Subject: Response to Notice of Deficiency dated November 8, 2001 – Pond 18 Closure Plan, Volume1-3. Astaris Idaho LLC. EPA ID No. IDD 07092 9518

EPA GENERAL COMMENTS and ASTARIS RESPONSES

POND 18 CLOSURE PLAN, Volume 1 and 2, Cell A

BECHTEL ENVIRONMENTAL, INC. SAN FRANCISCO		
ASTARIS IDAHO, LLC POCATELLO, IDAHO		
Pond 18 FT-IR RELOCATION PLAN		
Job Number	Drawing No.	Rev.
24230	Figure 8-1	0

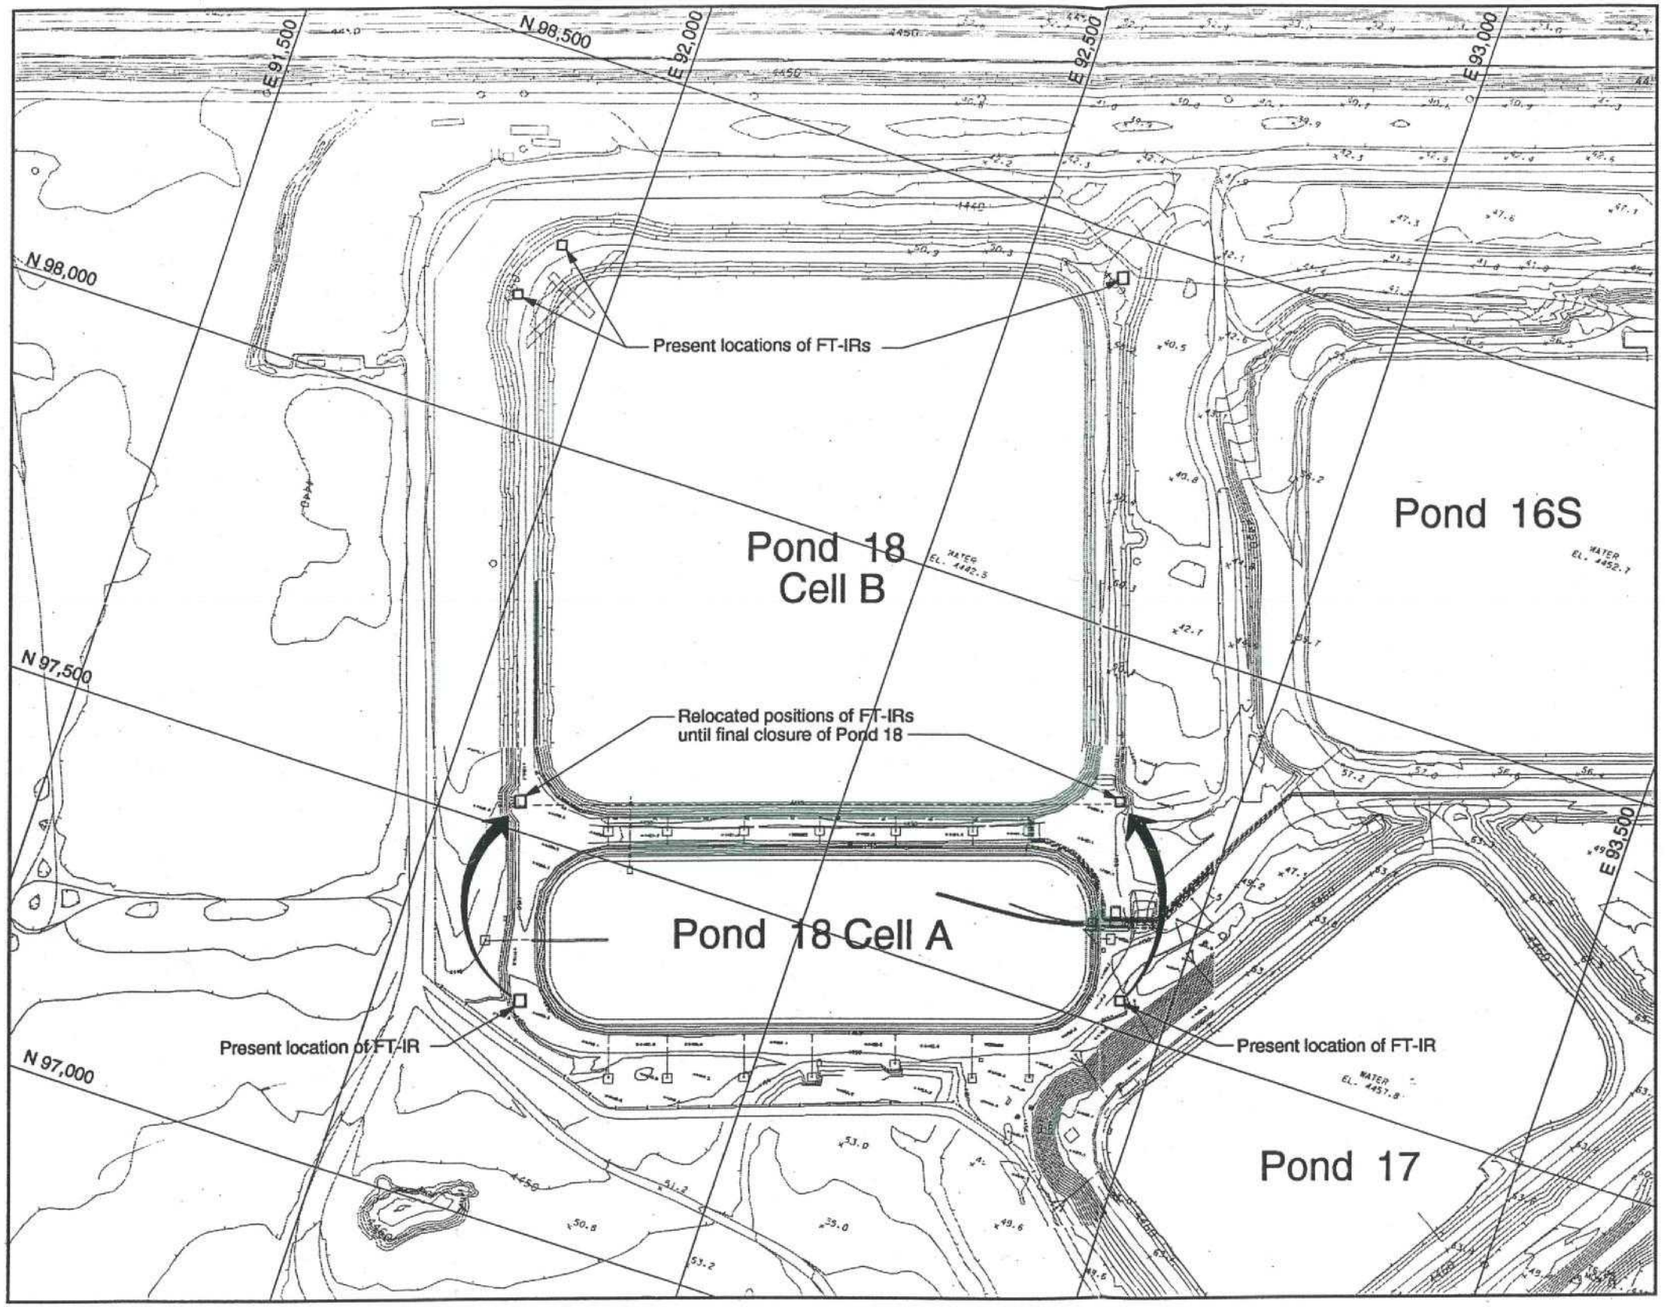
24. Section 8.6.2.2, Page 8-9

The specific locations the pond emission monitoring system (FTIR) will be relocated to and reinstalled must be provided in the plan. Plans for continued monitoring at the FTIR locations, at the fence line, and off site and responses if thresholds are exceeded must be included.

Response: A new drawing (Figure 8-1, copy attached) will be added to Section 8.6.2.2 that shows the current and future locations of the Pond 18 FT-IRs. A reference will be added to the end of the "FT-IR System Management and Removal" subsection of Section 8.6.2.2. During periods where the FT-IRs are inoperable, monitoring will continue to be performed by the construction work. Each work crew performing work in the pond area will have a personal phosphine monitor and work rules for all pond closure activities will be in full conformance to the requirements of the Plant Worker Safety Procedure as outlined in the RCRA Pond Management Plan and the Task-Specific Health and Safety Plan for Pond 18 (Appendix E). The personal phosphine monitor(s) have been and will continue to be a far more effective method for monitoring personnel exposures and taking appropriate action to minimize worker exposures. Procedures for contingent monitoring at the fence line and off site for the case where thresholds are exceeded at the FT-IR locations are addressed in Sections 3.3.2.3 and 3.3.3 of the PMP. No revisions to the Closure Plan are necessary.

1. The FT-IR units located at the southwest and southeast corners of Cell A will be relocated to the southwest and southeast corners of Cell B during placement of the initial fill in Cell A. All five FT-IR units will be removed by completion of closure of Pond 18.
